SAFETY EVALUATION BY THE
OFFICE OF NUCLEAR REACTOR REGULATION
SUPPORTING AMENDMENT NO. 22 TO
FACILITY OPERATING LICENSE NO. R-77
STATE UNIVERSITY OF NEW YORK AT BUFFALO
DOCKET NO. 50-57

By letter dated May 10, 1994, the State University of New York (SUNY) at Buffalo (the licensee), requested that their Technical Specifications (TS) be revised to accommodate removal of the primary loop heat exchanger. Since the heat exchanger is included in TS Section 5.4 as part of the primary cooling system, justification had to be developed for removing the heat exchanger from the TS.

PRIMARY COOLANT SYSTEM

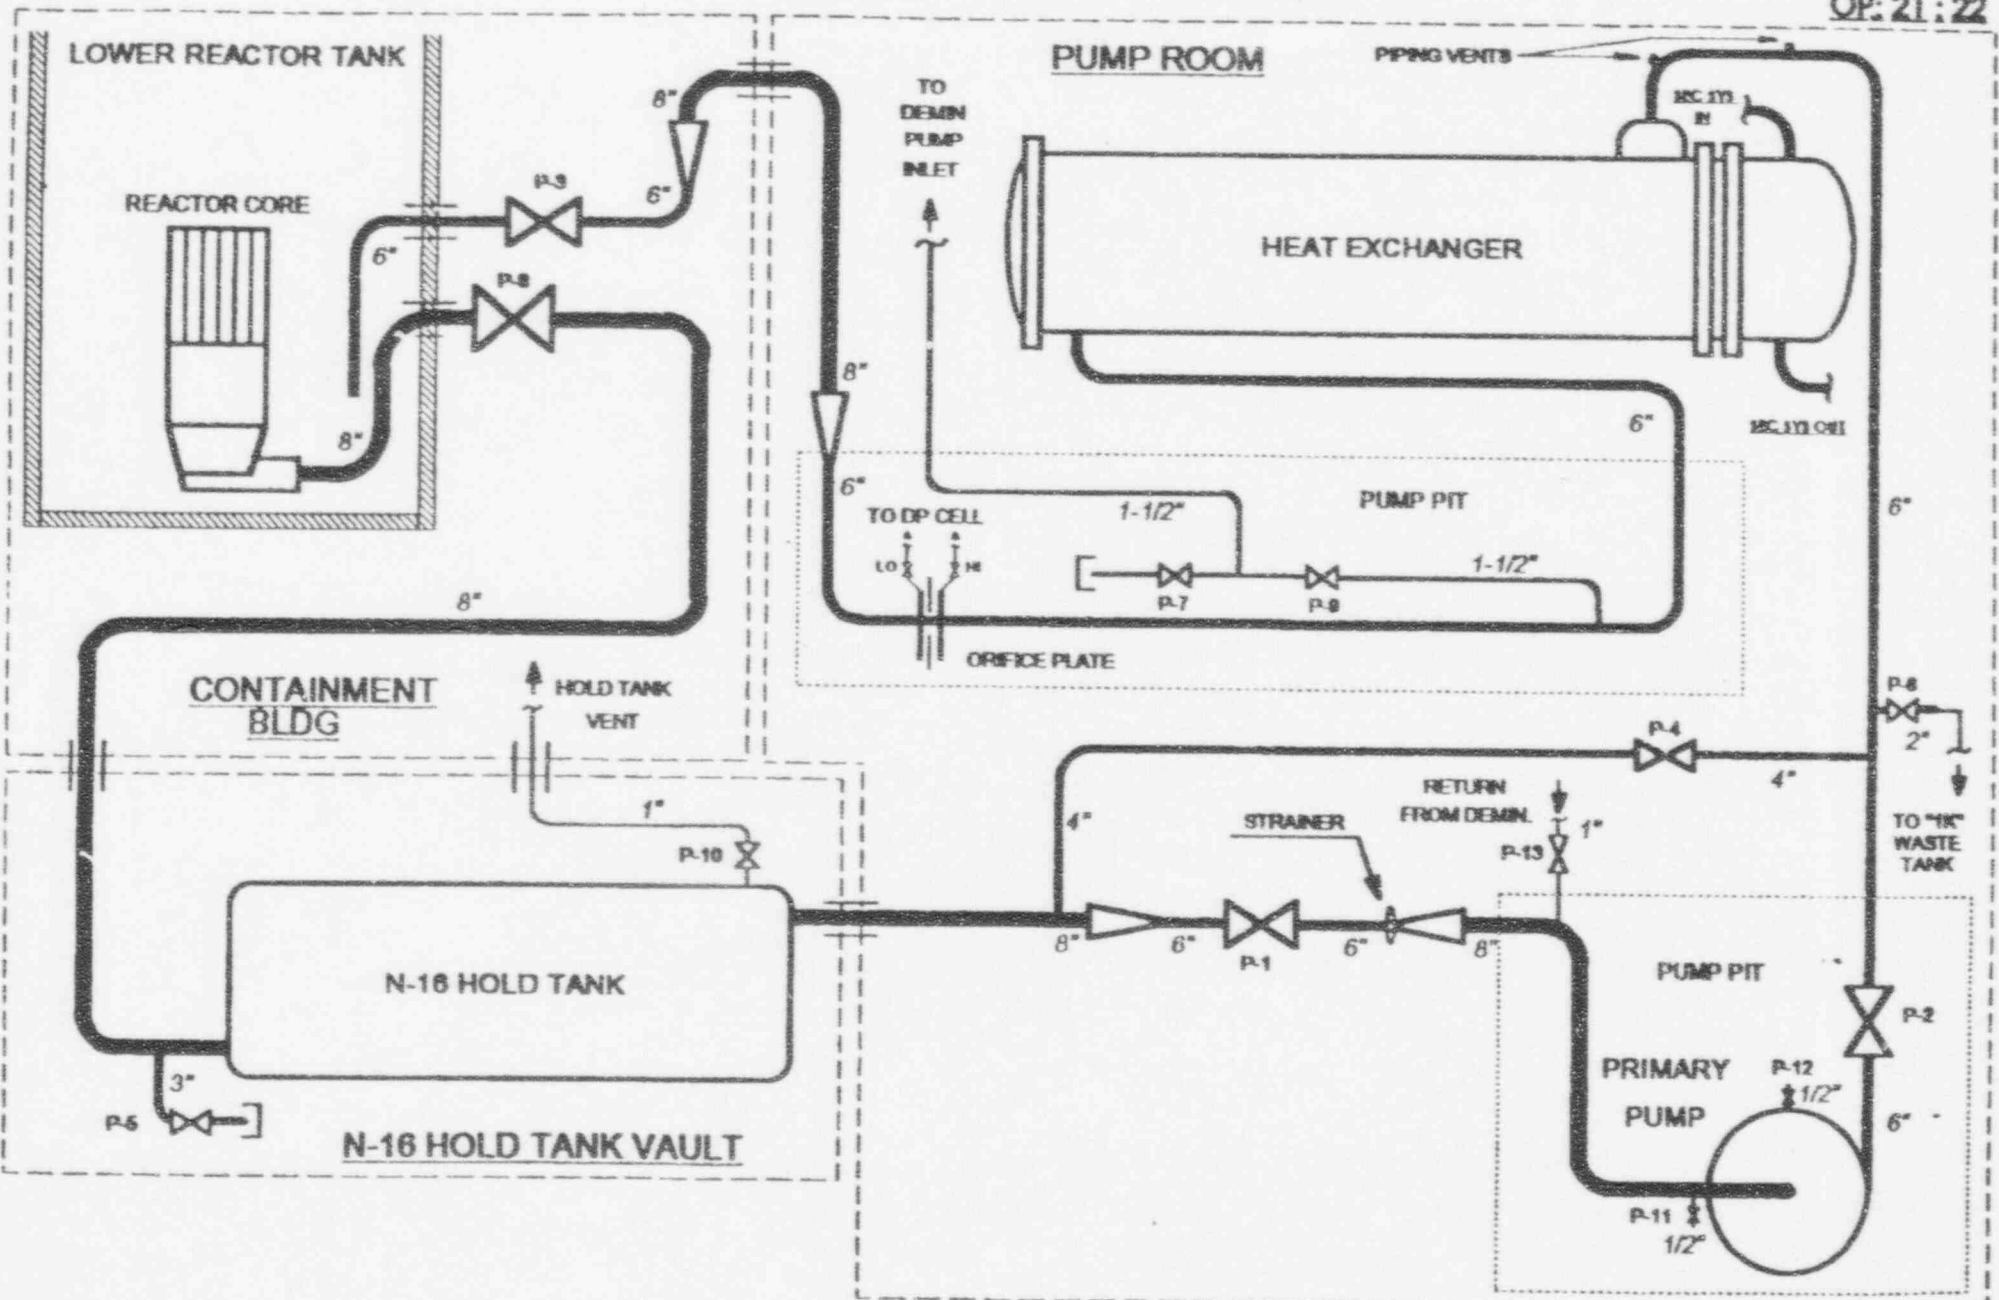
The licensee is planning to replace the heat exchanger with an aluminum pipe. The reason for this is to allow water to circulate when the reactor is not running so that proper mixing of the primary coolant can be maintained, to improve water quality through use of the demineralizer, and to prevent stagnation in the N-16 decay tank. When the reactor is in the natural convection mode, this loop will not be in operation as is the case presently with the heat exchanger in the loop. In the natural convection mode, the primary outlet valve (P-2) is left closed (see enclosed diagram) and the heat exchanger is essentially valved off. Therefore, operation of the reactor in the natural convection mode without a heat exchanger would not be different than the natural convection mode operation with a heat exchanger. The staff finds that substitution of an aluminum pipe in place of the heat exchanger and a reduction in the licensed power level from 2 MW to 250 KW acceptable.
